The
WHITE PINE
SERIES OF
Architectural Monographs
Volume VII **Number 4**

Designs for a
THREE TEACHER
RURAL SCHOOL
With Teachers' Cottage

A THREE-TEACHER RURAL SCHOOL WITH TEACHERS' COTTAGE

REPORT OF THE JURY OF AWARD OF THE SIXTH ANNUAL WHITE PINE ARCHITECTURAL COMPETITION

FIRST PRIZE DESIGN, Detail Sheet

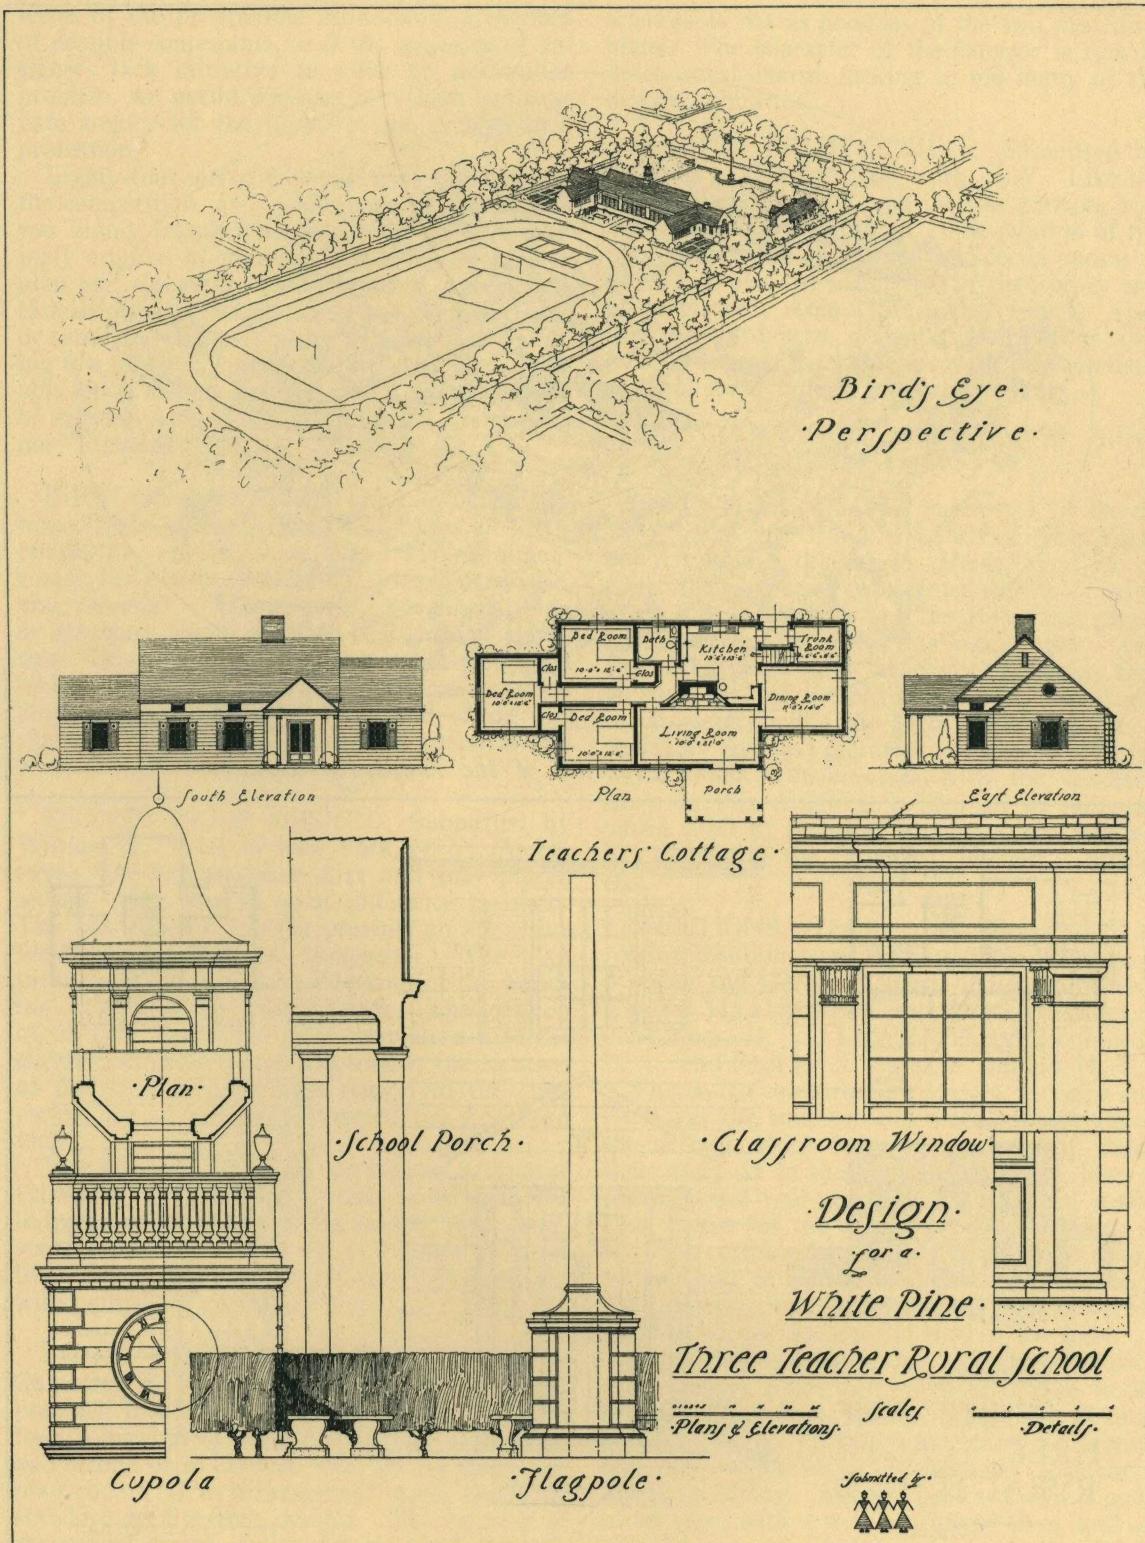
FIRST PRIZE DESIGN. Submitted by Antonio DiNardo and W. Frank Hitchens, of Pittsburgh, Pa. Architecture, being a three-dimensional subject, cannot be considered otherwise, and, therefore, it becomes not a question of plan or elevation, but a question of plan and elevation. This design had a well articulated plan which functioned admirably, and an elevation possessing the charm of light and shade and shadow. The "porch," both as a practical and as an æsthetic feature, is attractive.

SECOND PRIZE DESIGN
Submitted by William D. Foster, New York, N. Y.

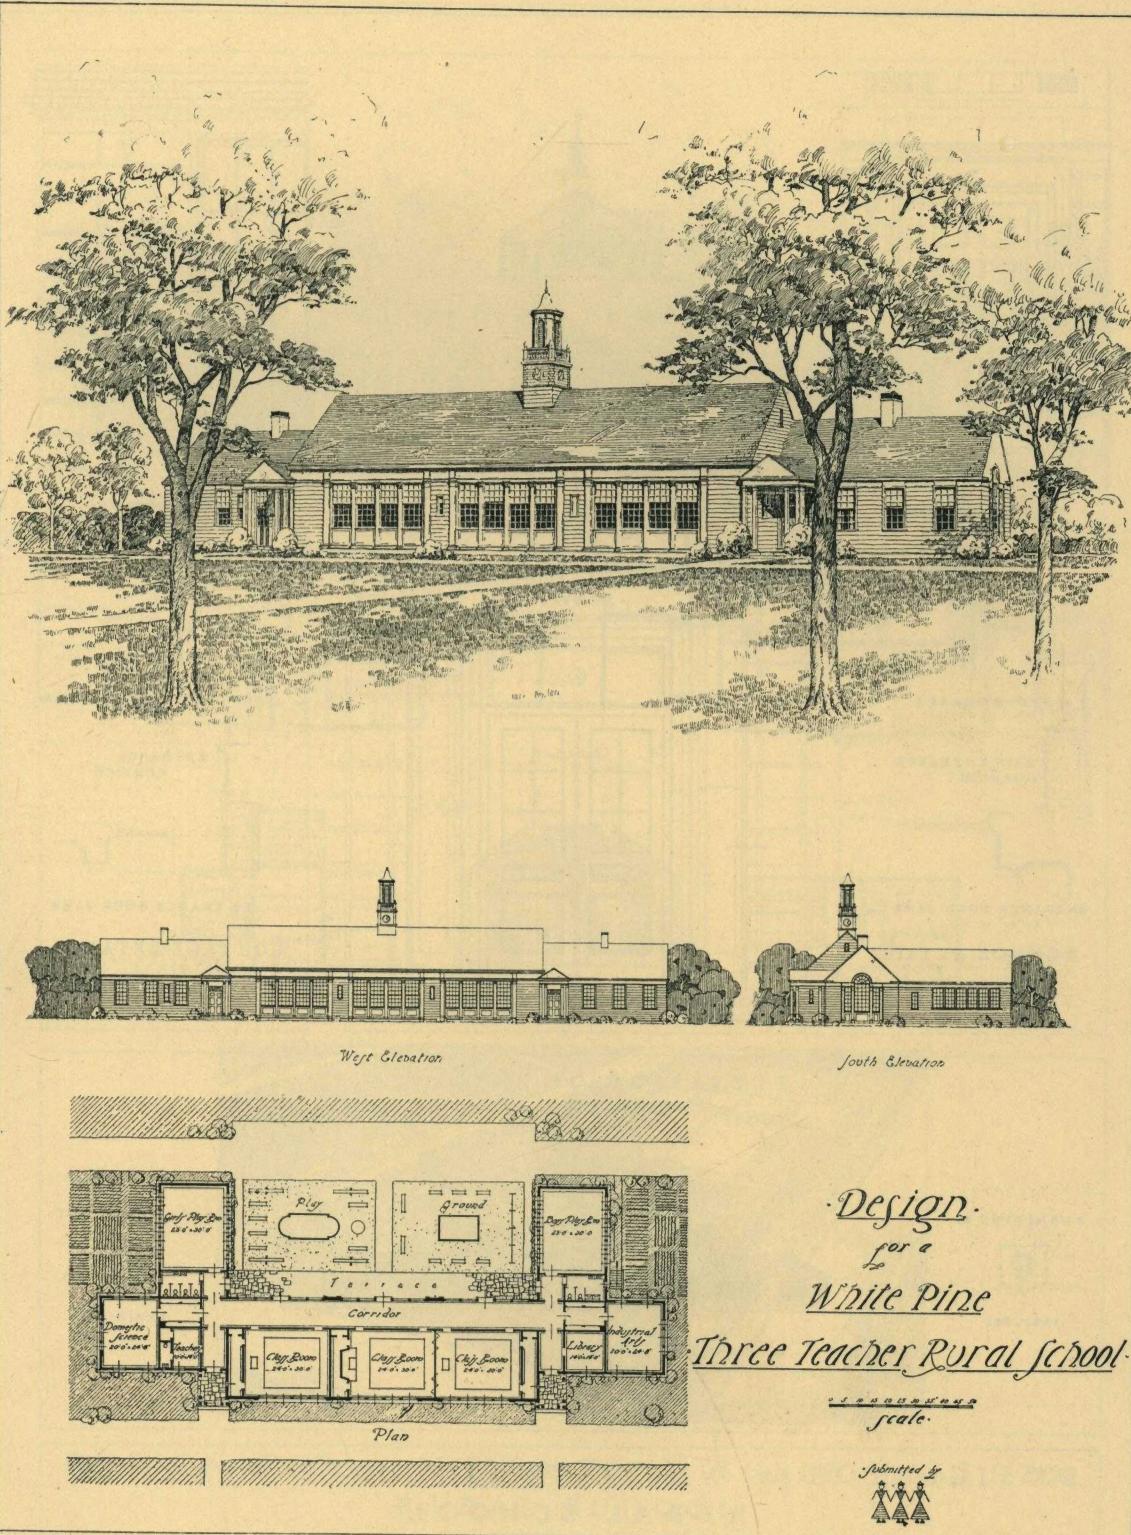
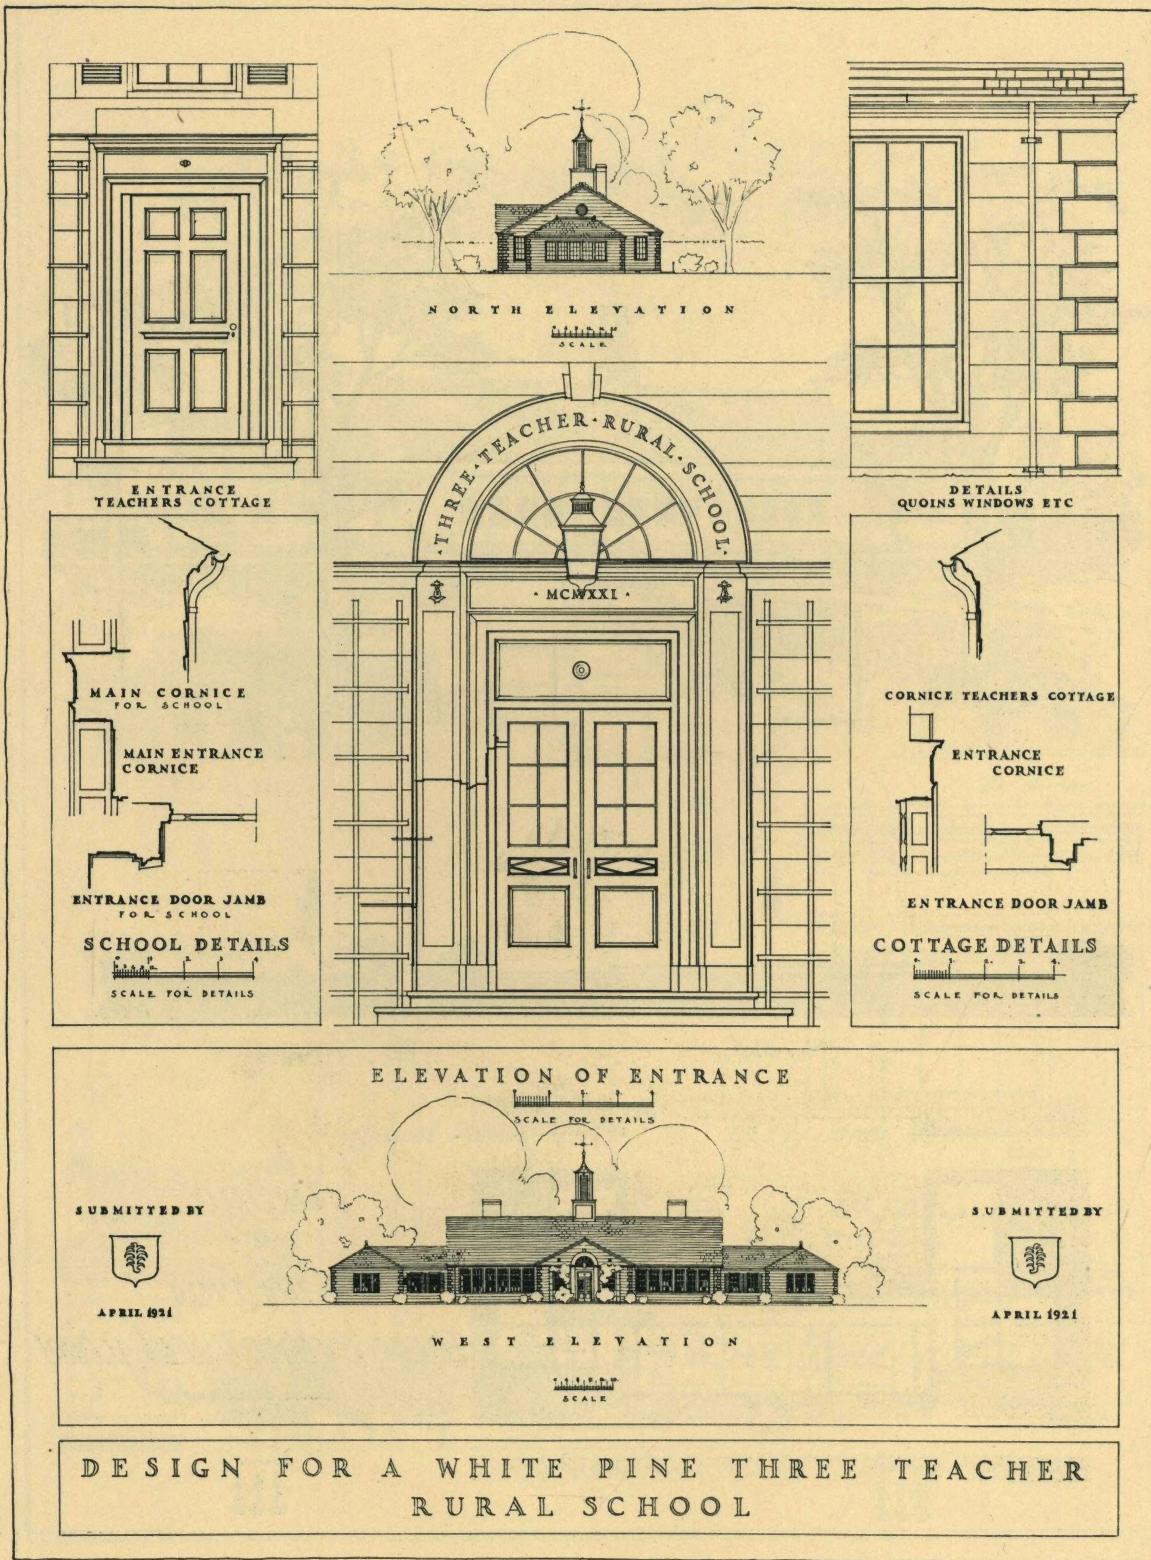
SECOND PRIZE DESIGN. Submitted by William D. Foster, of New York, N. Y. As between the design placed first and that placed second, there was no great difference in merit. The ample sunlit corridor presents an attractive feature excelled by no competitor. The plan turns the most attractive elevation of the building away from the Village Green. The location of the play rooms and their correlation with the out-of-door play spaces and toilets, the location of the special rooms with respect to the class rooms, are admirable features of this fine open plan.

The one-story teachers' cottage is attractive exteriorly, but not well studied as to plan, the living room being turned, necessarily, into a runway, interfering with its use as a center of social life. The kitchen is not any too well equipped with pantries or storage closets.

THIRD PRIZE DESIGN, Detail Sheet
Submitted by Chauncey F. Hudson, Buffalo, N. Y.

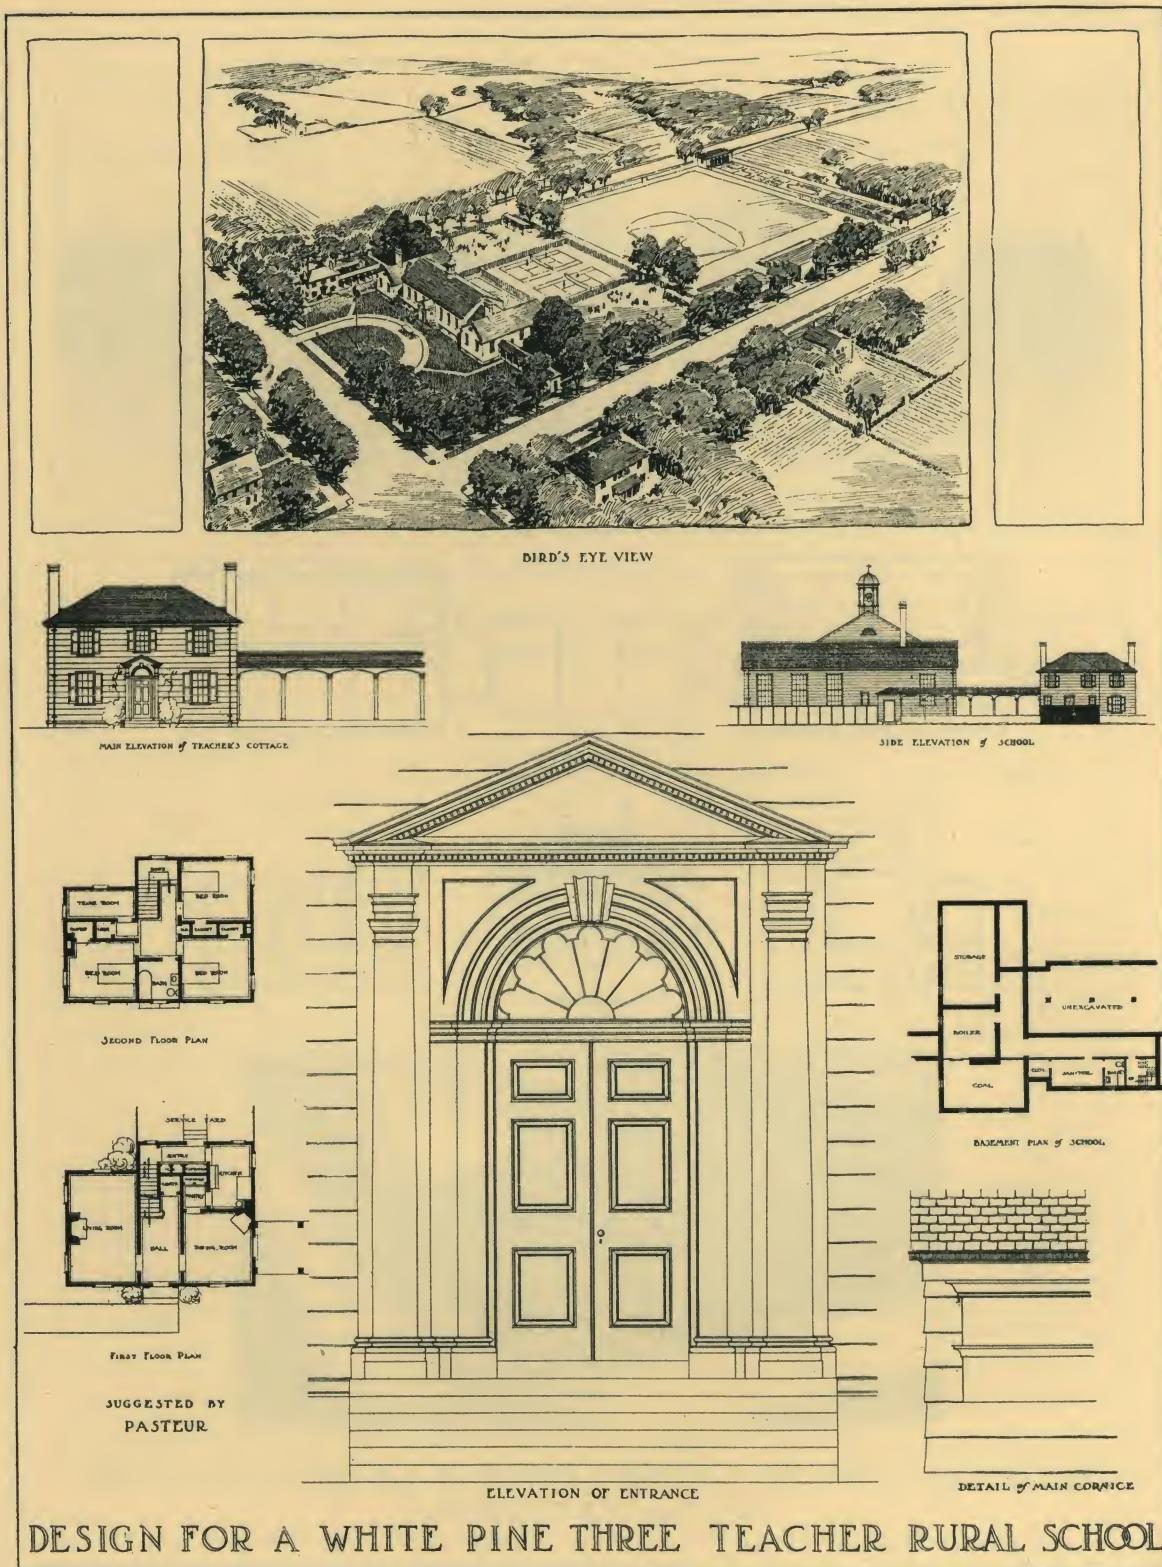
THIRD PRIZE DESIGN. Submitted by Chauncey F. Hudson, of Buffalo, N. Y. This plan fell into the interior corridor type, and so loses somewhat of the attractiveness of the first and second prize designs. Nor do the toilet and play rooms, as to arrangement, quite reach the standard set by those designs. The location of the special rooms—industrial arts and domestic

science—is not as good as in the two preceding plans. The character of the exterior is rich in quiet, rural charm, lacking in too many of the designs submitted.

FOURTH PRIZE DESIGN, Detail Sheet

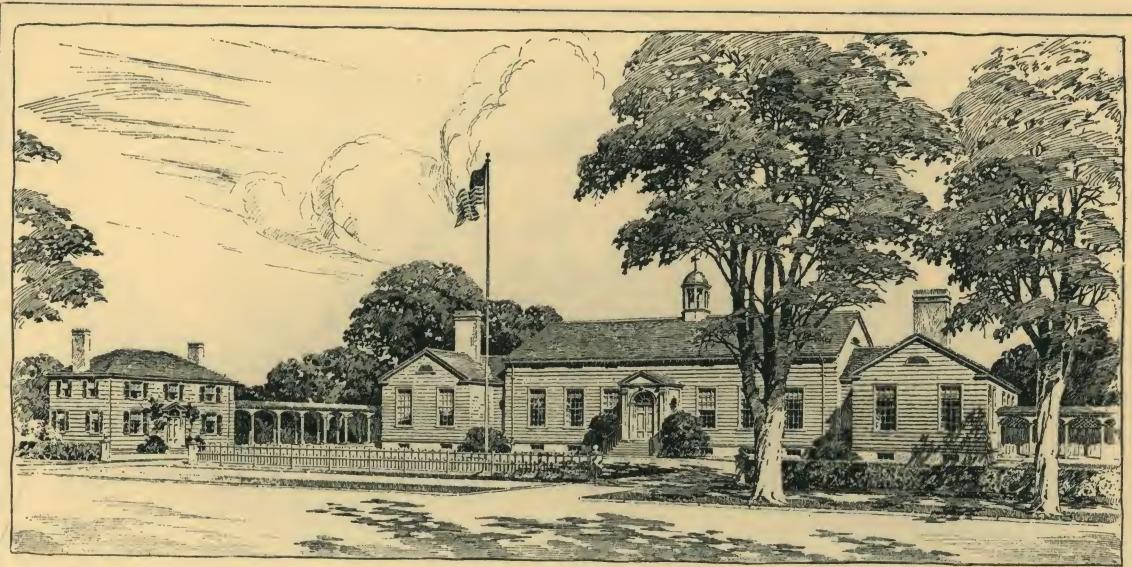
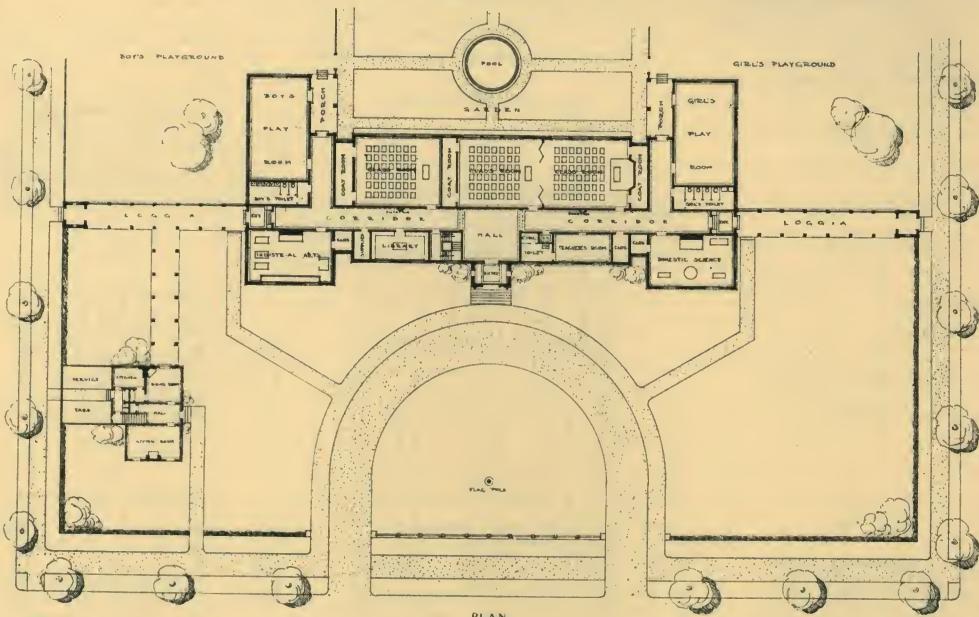
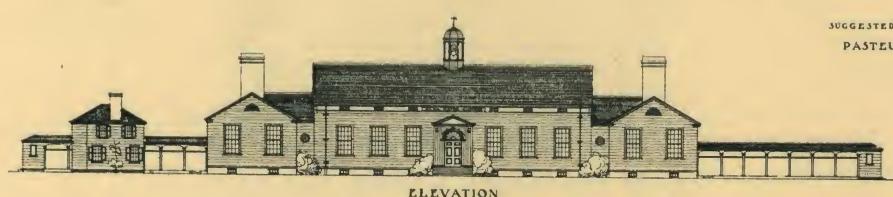
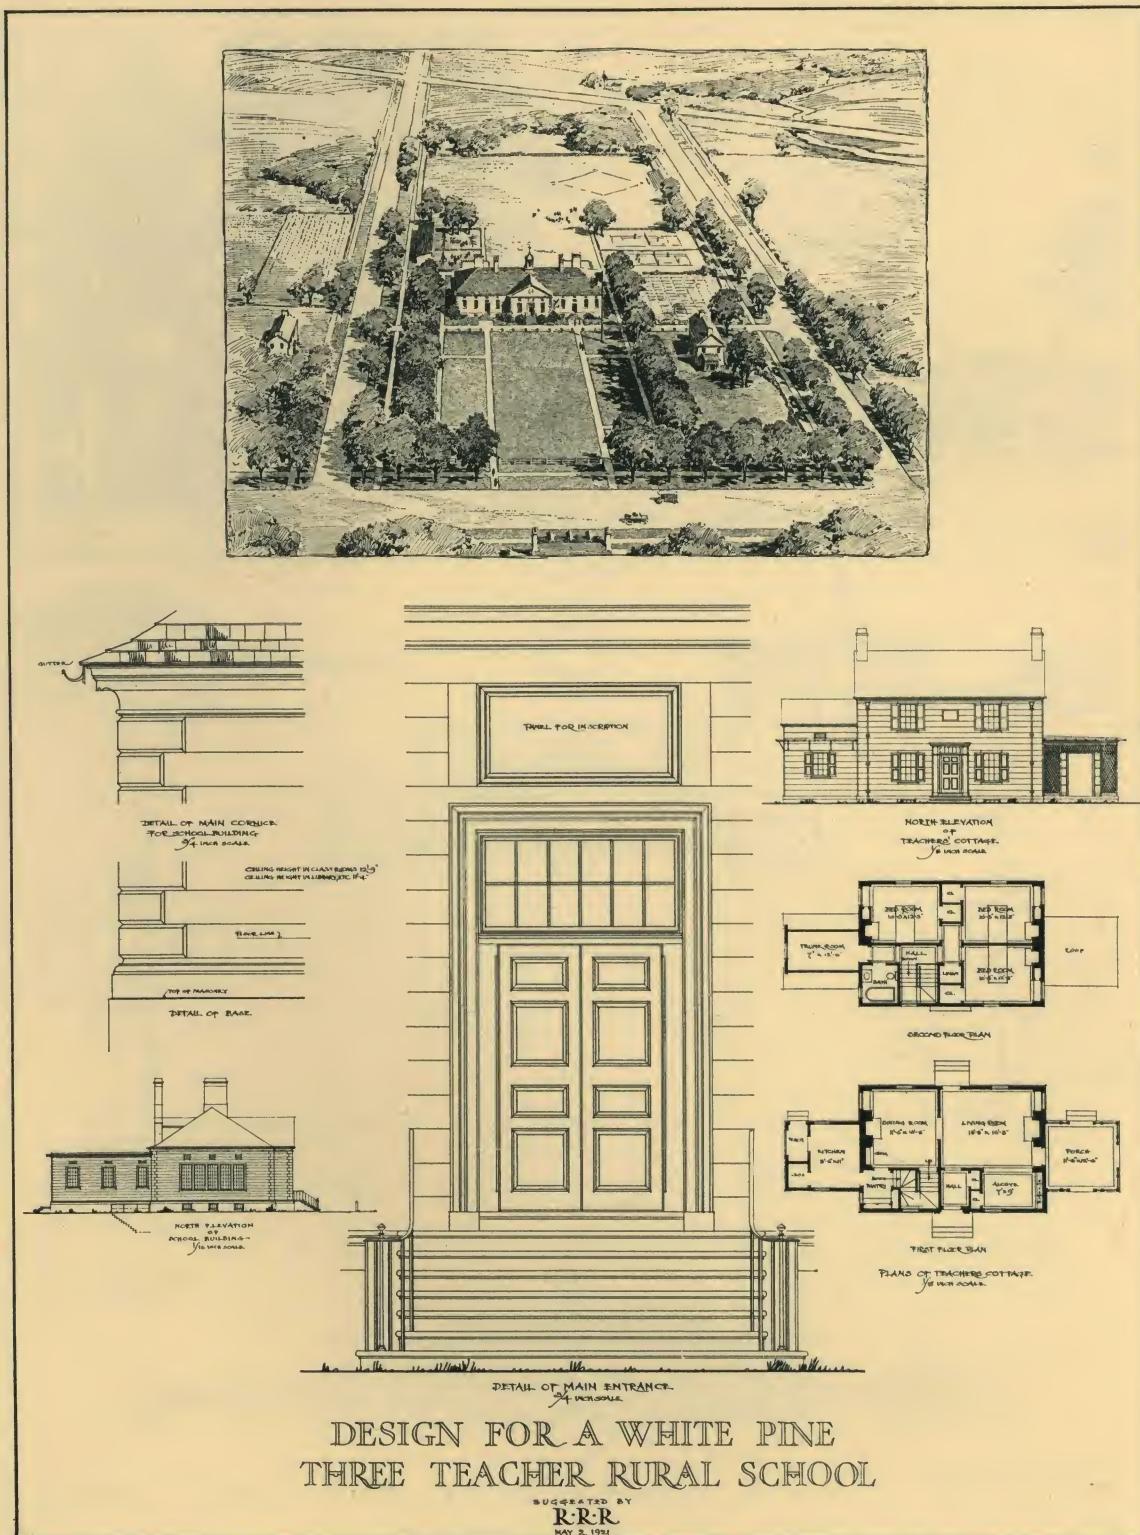
FOURTH PRIZE DESIGN. Submitted by Robbins L. Conn, of New York, N. Y. Like the design placed third, a long interior corridor was introduced into this design. The relation of the play rooms and toilets to the special rooms is good, as is also the correlation of the library and of the teachers' room with the class rooms. Also, like the third prize design, the elevations adequately express that which is most characteristic of rural surroundings, a leisurely charm.
